Decision Document

Environmental Protection Act 1986, Part V

Licence: L6756/1996/11

Premises address: Buller Road Refuse Disposal Site
702 Buller Rd
WAROONA WA 6215
Being Lot 1701 on Plan 214632

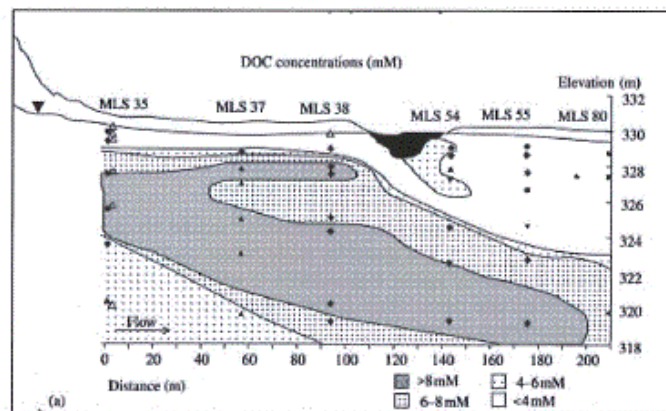
The absence of clusters of bores that monitor different depths within the aquifer at specific monitoring locations suggests that the managers of the landfill site have not considered the likelihood that a groundwater contamination plume from waste disposal facility will increase in depth in the superficial aquifer with increasing distance downgradient of the site (Fig. 2) because of the higher density of contaminated groundwater than natural uncontaminated groundwater.

This means that there is a significant risk that bores constructed at shallow depth downgradient of a landfill site would not detect the presence of groundwater contamination from waste disposal at the site. For instance, a bore constructed at site MLS 55 in Figure 2 with a screened-interval from the water table to a depth of 3 metres below the water table (a typical method of construction for many monitoring bores) would not detect contamination from the illustrated landfill site.

Additional monitoring bores constructed at monitoring site MB2 would enable groundwater contamination by landfill leachate to be detected at various depths in the superficial aquifer. A similar bore-cluster near the southwestern corner of the proposed new waste disposal area would provide baseline groundwater quality data for this area. The addition of a number of chemical parameters to the current analytical suite for the sampling program would enable changes in groundwater quality to be associated with contamination by landfill leachate and would allow environmental risks associated with trace chemical constituents to be determined. These issues are discussed in more detail in Section 5.3 of this report.
